17TH STREET CANAL - PHASE 1B

HAMMOND HIGHWAY TO SOUTHERN RAILWAY

The following revised slope stability and sheet pile design calculations address all comments made in the Corps' letter of April 25, 1989. A brief description of the revisions made to the cross-sections since the last submittal of April 10, 1989, is given for each of the eight reaches. Also given for each of the reaches is a listing of new submittals, stating which of the Corps' comments were addressed.

CANAL SIDE FAILURESTA. 564 + 00

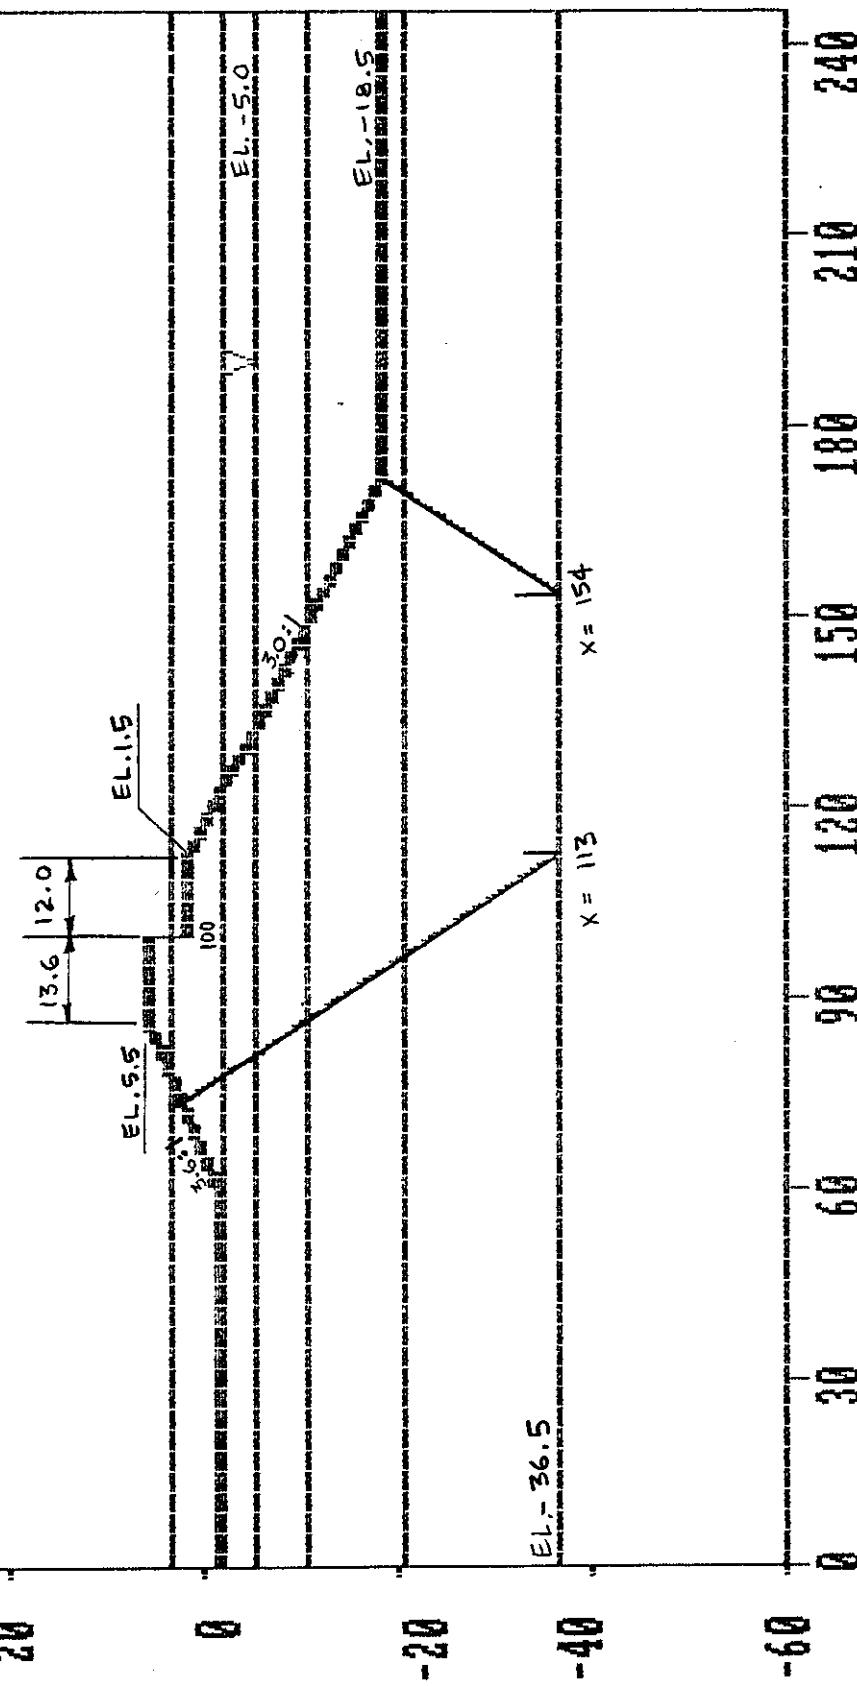
Revisions :

1. Entire sheet pile wall moved 0.5' closer to the canal thus increasing the crown width 0.5' along the entire reach.
2. Step elevation lowered from El. 2.0 to El. 1.5.

Canalside Failure - 562+00, 564+00 and 566+00. The section at Sta. 564+00 governs.
*** Minimum Factor of Safety = 1.32 at El. -36.5 ***

STA. 560+00

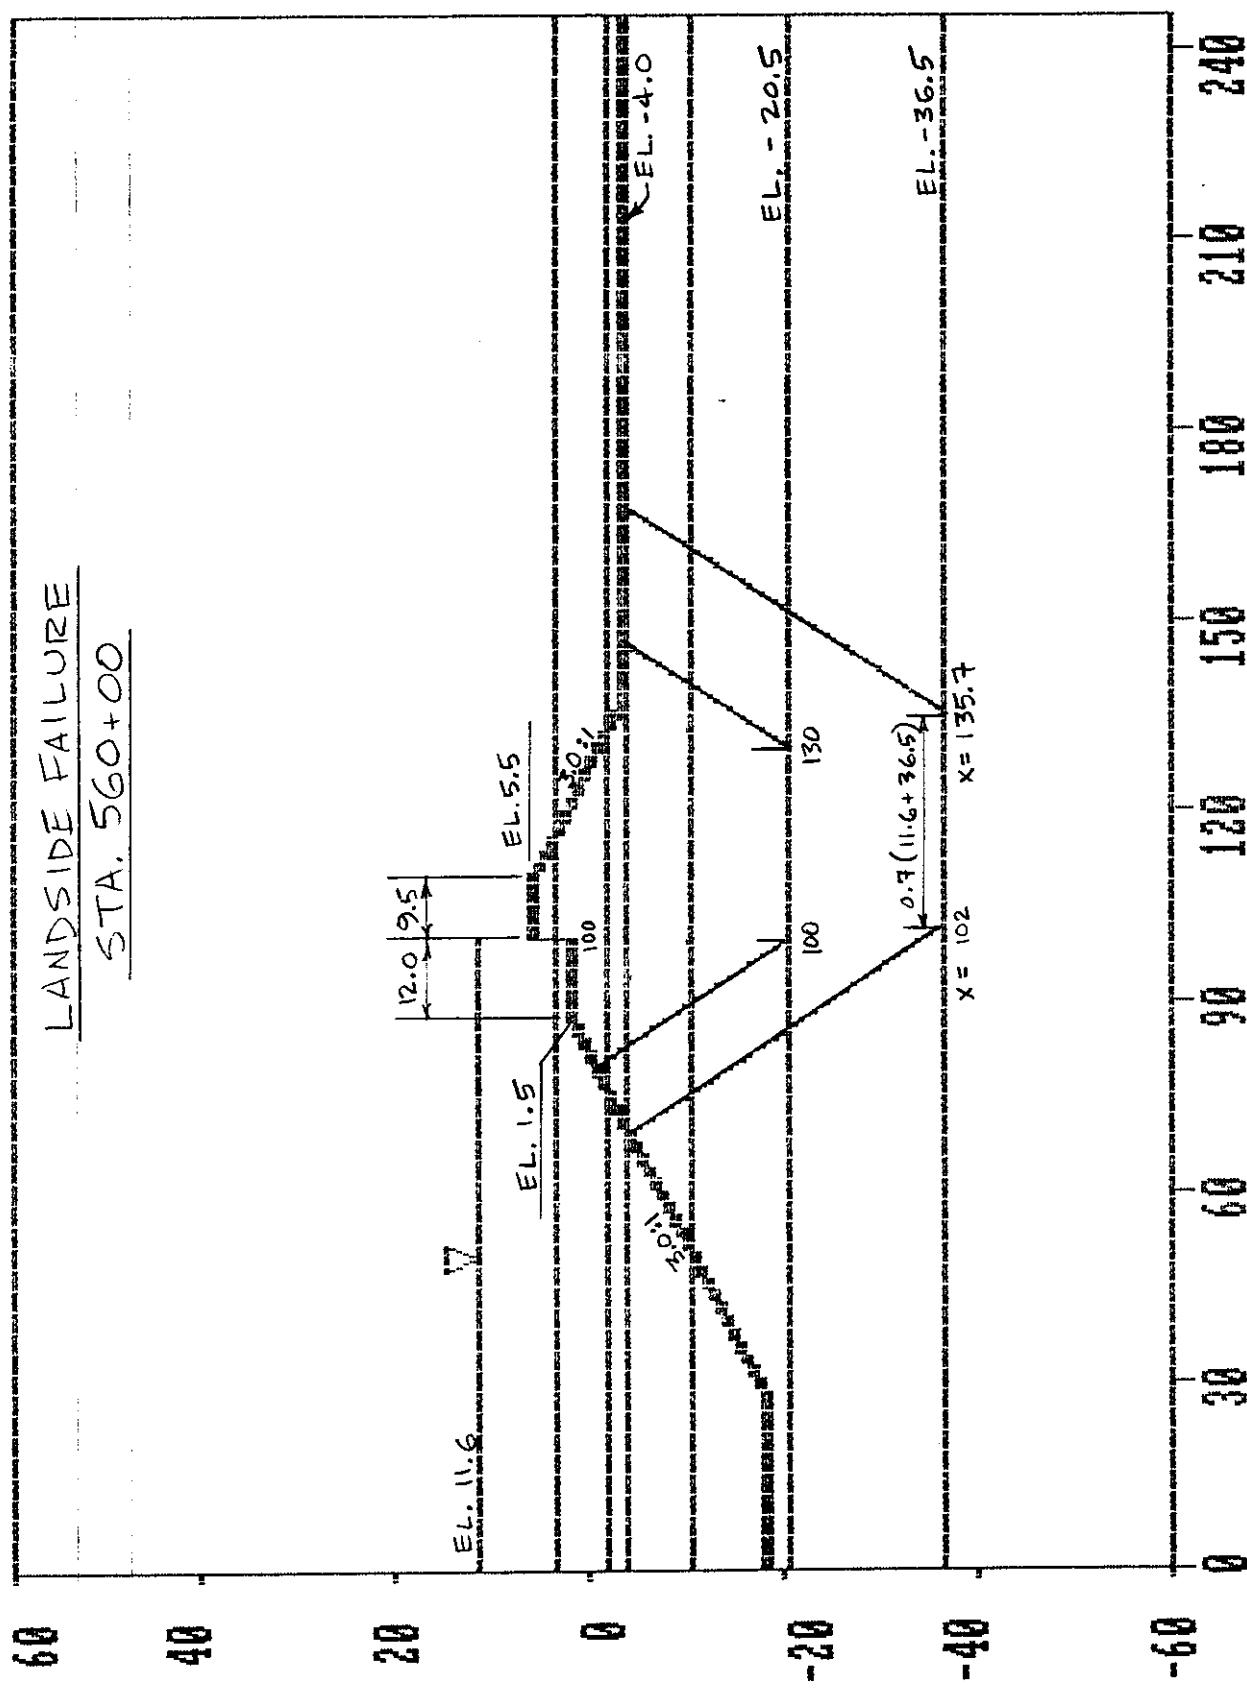
1. New canalside stability analyses taking into account the above revisions and the correction to the soil shear strength from El. 0.0 to El. -2.0.
2. New landside stability analyses taking into account the above revisions and including calculations at El. -20.5.
2. New sheet pile analyses taking into account the above revisions and the submerged canalside soil weight.

Landside Failure - 554+00, 556+00, 560+00 and 562+00. The section at Sta. 568+00 governs.
*** Minimum Factor of Safety = 1.38 at El. -28.5 ***

STA. 570+00

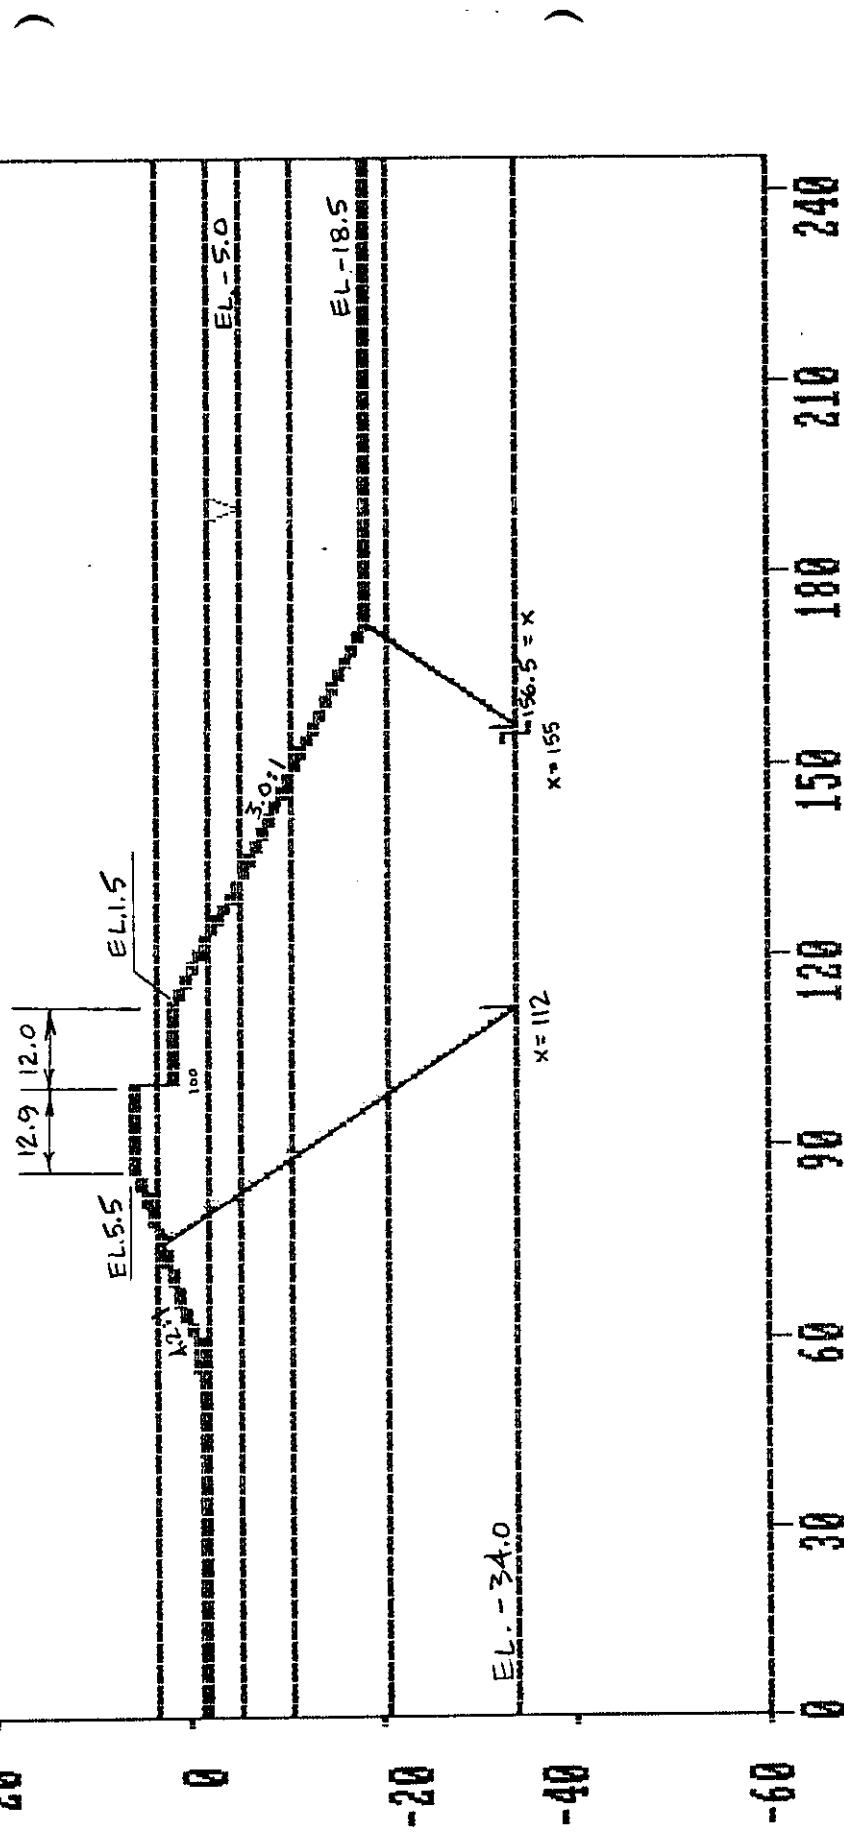
1. Entire sheet pile wall moved 0.5' closer to the canal thus increasing the crown width 0.5' along the entire reach.
2. Step elevation lowered from El. 2.0 to El. 1.5.
3. Step width increased from 9.0' to 12.0'.

Canalside Failure - 570+00.
*** Minimum Factor of Safety = 1.35 at El. -34.0 ***

STA. 576+00

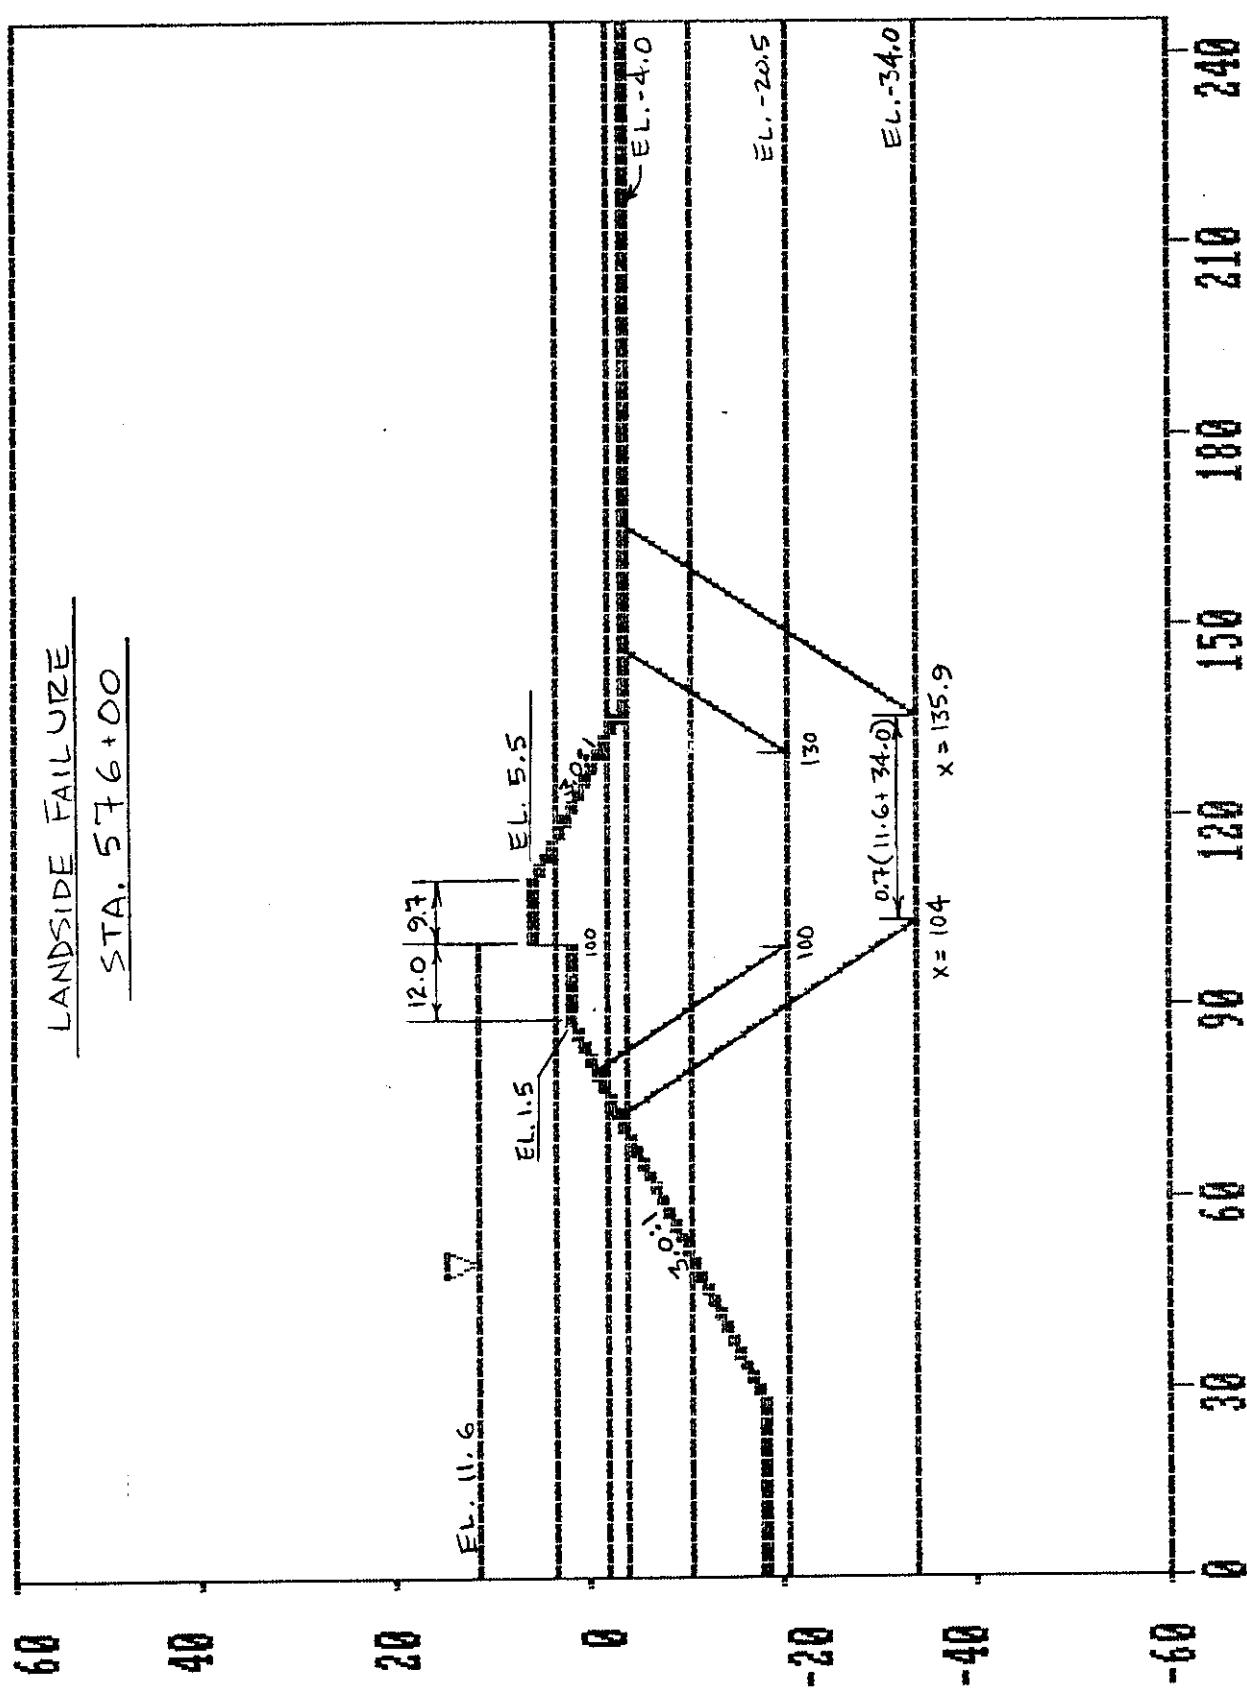
1. New canalside stability analyses taking into account the above revisions and the correction to the soil shear strength from El. 0.0 to El. -2.0.
2. New landside stability analyses taking into account the above revisions and including calculations at El. -20.5.
3. New sheet pile analyses taking into account the above revisions and the submerged canalside soil weight.

Landslide Failure - 576+00, 578+00, 584+00 and 588+00. The section at Sta. 576+00 governs.
*** Minimum Factor of Safety = 1.30 at El. -34.0 ***

STA. 612+00

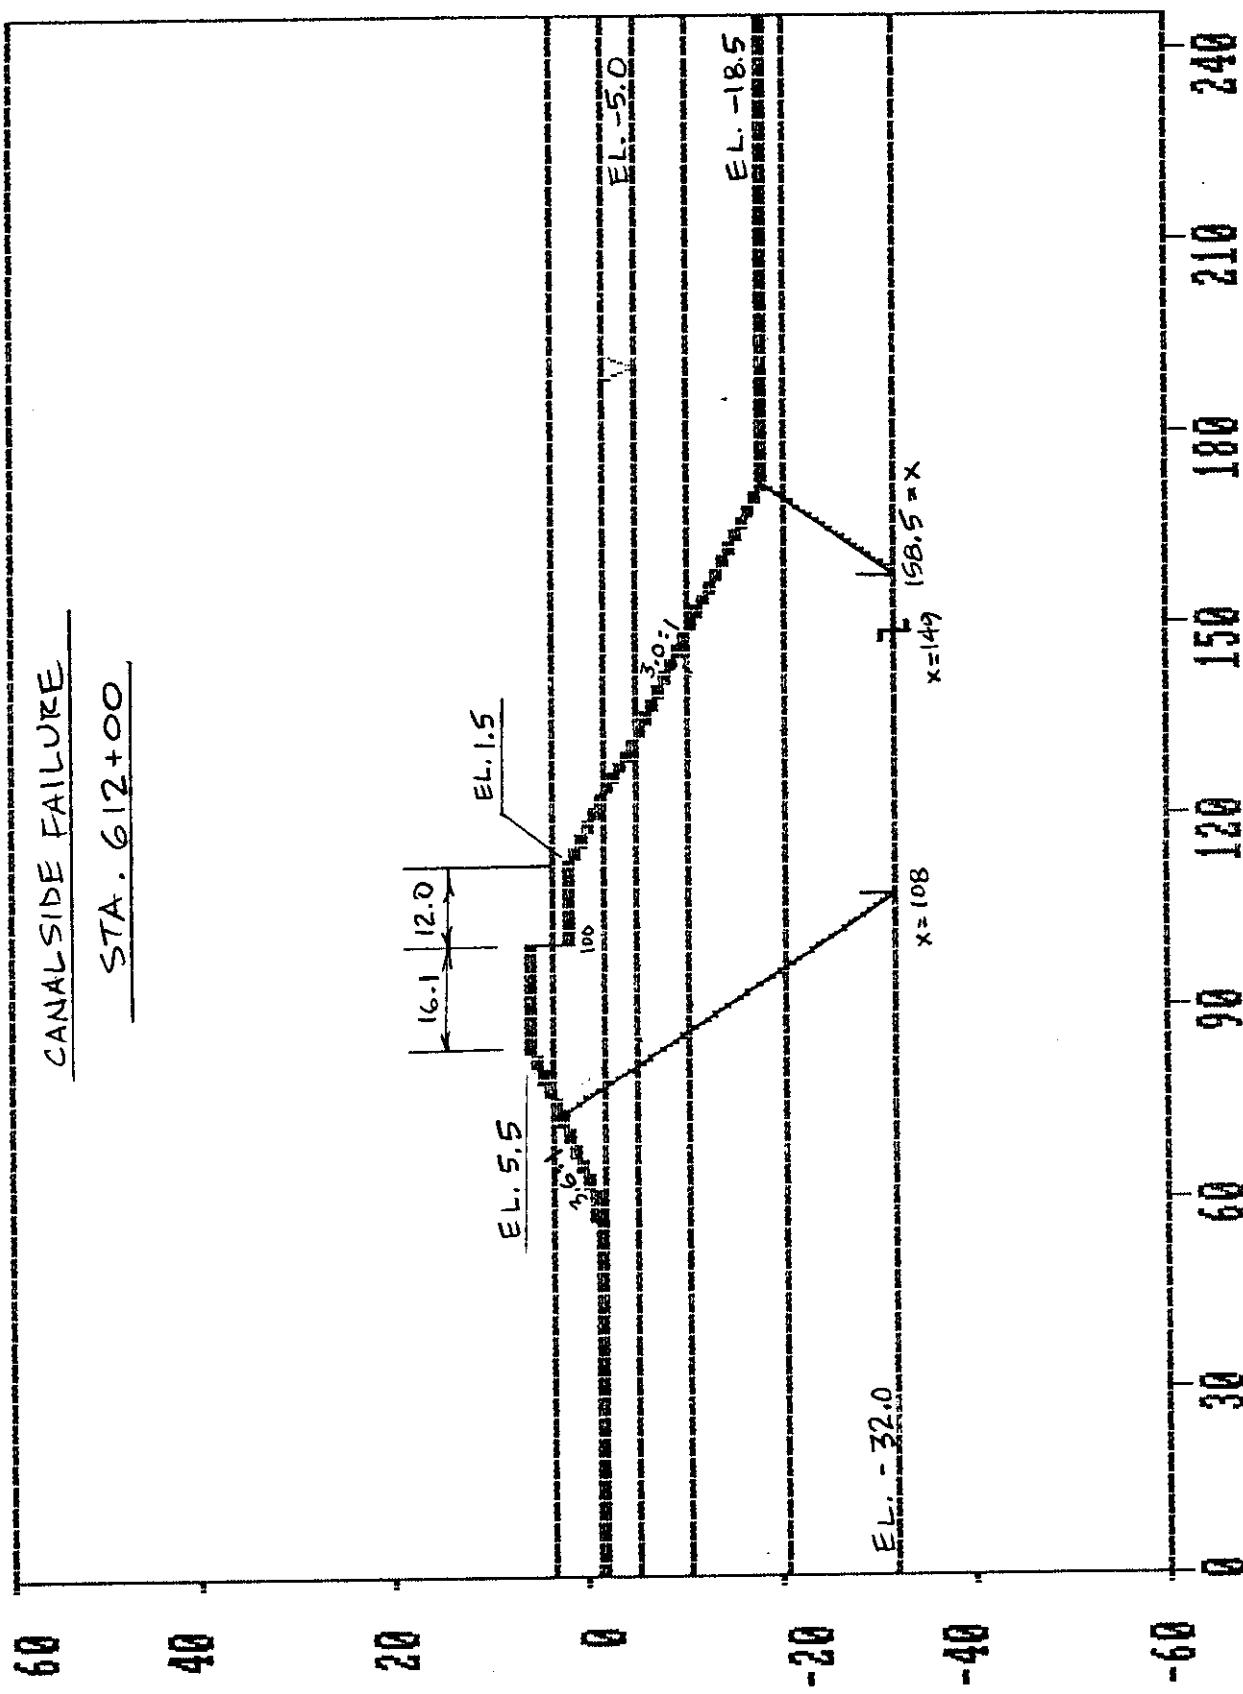
1. Entire sheet pile wall moved 0.5' closer to the canal thus increasing the crown width 0.5' along the entire reach.
2. Step elevation lowered from El. 2.0 to El. 1.5.
3. Step width increased from 9.0' to 12.0'.
4. Add 6" of fill from the levee toe to a distance 30' from the levee toe in the vacant lot referenced.

Canalside Failure - 612+00. *** Minimum Factor of Safety = 1.36 at El. -32.0 ***
